TECHNICAL SERVICE BULLETIN

Number: TSB-FC-2020-001

Symptom: Wheel encoder contact with platform

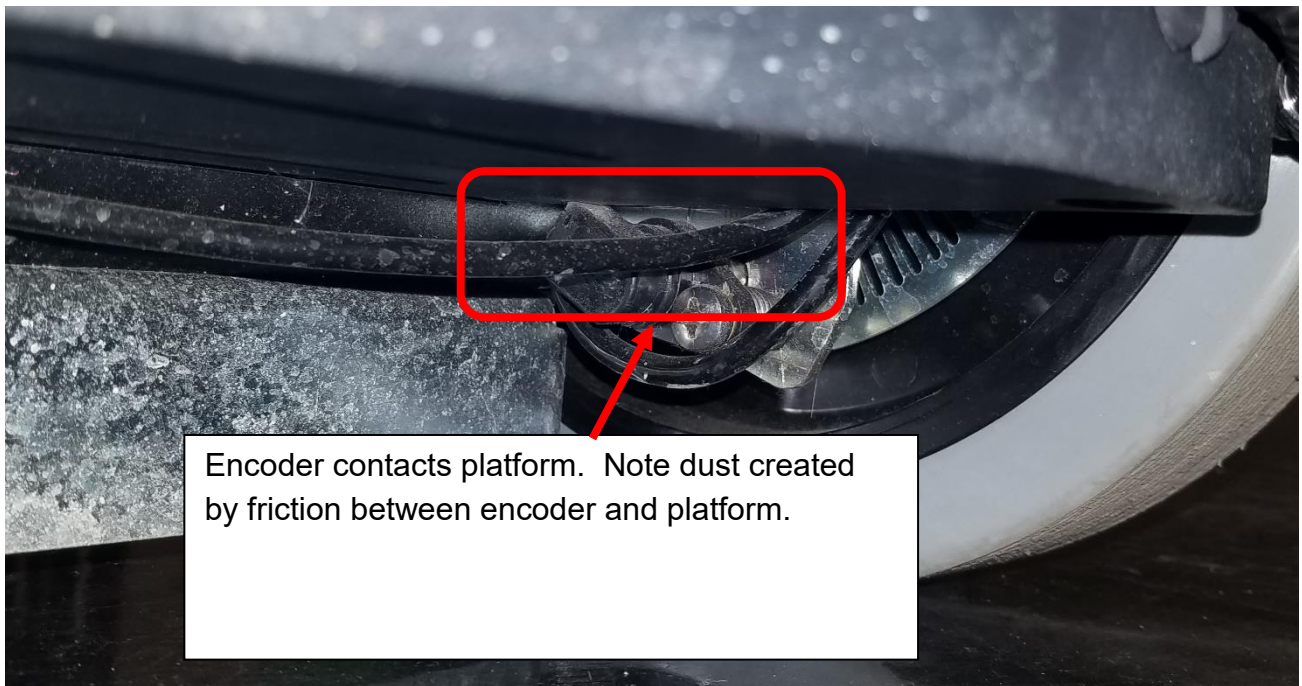
Gap between the 56104537 rear wheel encoder and the 56104551 encoder plate is less than 0.010 inches or more than 0.060 inches on any point around the plate. This could be caused by different reasons including: incorrect adjustment made in the factory, missing Loctite in 56003950 screw that positions the 56104537 encoder on the 56104866 or 56104865 mounting brackets, excessive vibration or handling, or **the platform assembly contacting the encoder, particularly on the left side of the machine.**

ECO A-14305 implemented in November 15th, 2019 introduced 56122796 platform support that increases the clearance between the platform and the encoders, preventing undesired contact.

1. Request 56122807 kit and install per kit instructions.

Kit 56122807 NOT Installed

Kit 56122807 Installed
